[Docket No. 99-NM-65-AD]

Airworthiness Directives; Boeing Model 747 Series Airplanes Equipped With Pratt & Whitney JT9D-70 Series Engines

ACTION: Notice of proposed rulemaking (NPRM).

Figure 1

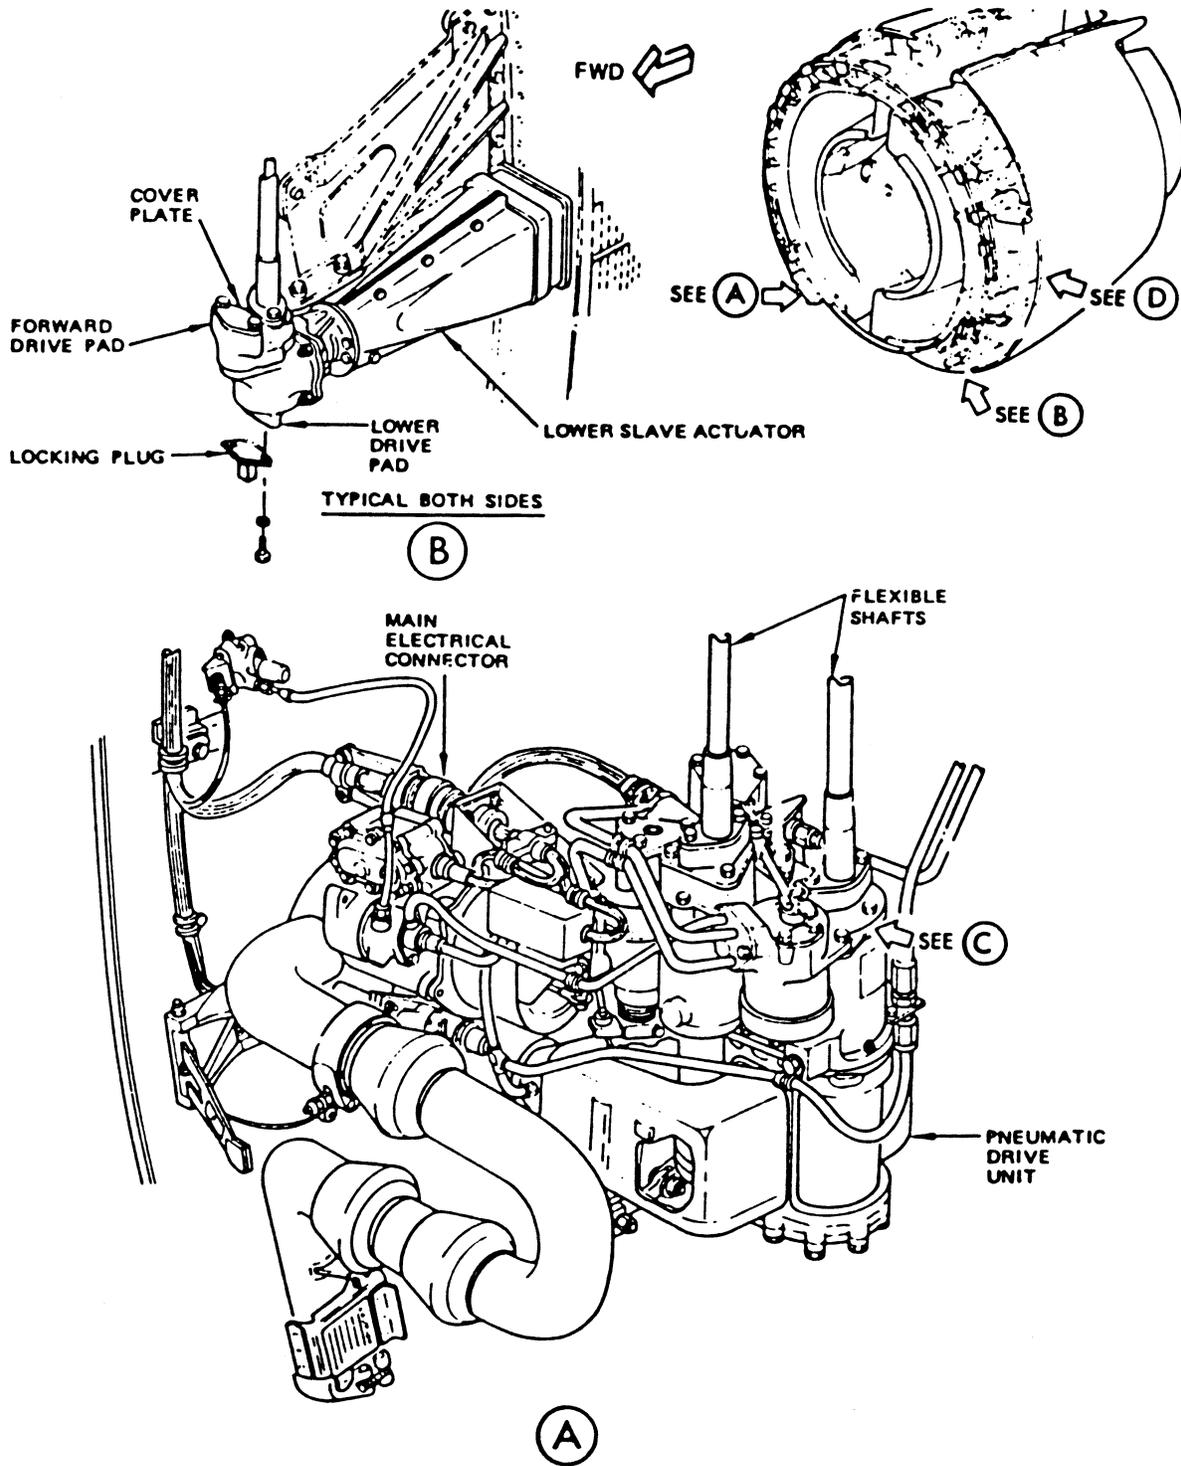
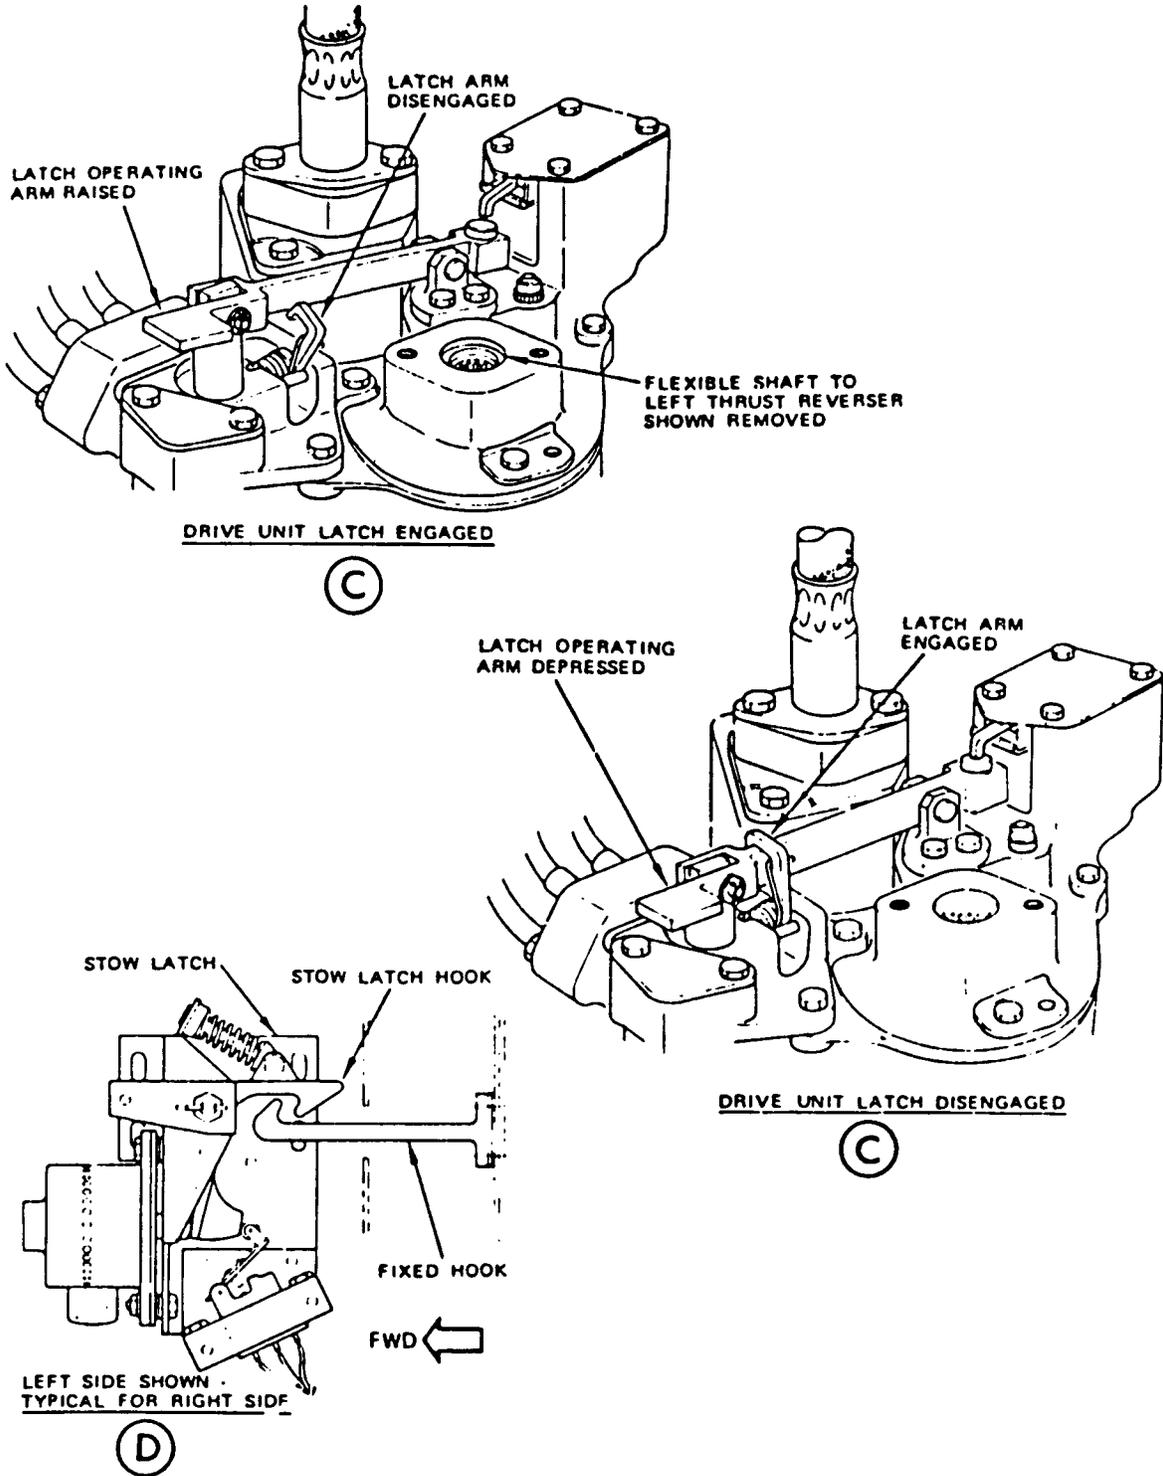
(f) Within 4,000 hours time-in-service after accomplishment of paragraph (e) of this AD: Perform a functional test to detect discrepancies of the additional locking system on each thrust reverser, in accordance with Appendix 1 (including Figures 1 and 2) of this AD. Prior to further flight, correct any discrepancy detected, in accordance with the procedures described in the Boeing 747 Airplane Maintenance Manual. Repeat the functional test thereafter at intervals not to exceed 4,000 hours time-in-service.

B. Prepare for the Thrust Reverser Sync Lock Test

- (4) Depress drive unit latch operating arm and retain by engaging latch arm (detail C).
- (5) Disengage stow latch hook on left and right thrust reversers (detail D).
- (6) On either lower slave actuator (detail B), either remove coverplate from forward drive pad or remove locking plug from lower drive pad.
- (7) Move left-hand sync-lock lever to the unlocked position.
- (8) Using appropriate drive adapter (196K8004-1 at forward drive pad or 196K8004-3 at lower drive pad), attempt to manually deploy sleeves.

- (9) If sleeves move, replace the right-hand sync-lock.
- (10) Move left-hand sync-lock lever to the locked position.
- (11) Move right-hand sync-lock lever to the unlocked position.
- (12) Repeat step (8) above.
- (13) If sleeves move, replace the left-hand sync-lock.
- (14) Move left-hand sync-lock lever to the unlocked position.

- (15) Rotate actuator gearshaft to fully stow the sleeves.
- (16) When translating sleeves reach stowed position, check that stow latch hooks have engaged fixed hooks on both sides (detail D).
- (17) Depress latch operating arm and disengage latch arm (detail C); allow latch arm to raise.
- (18) After releasing arm, verify latch engagement by attempting to rotate feedback gear on drive unit using 1/4-inch square drive; gear shall not rotate in excess of 0.1 of a turn.
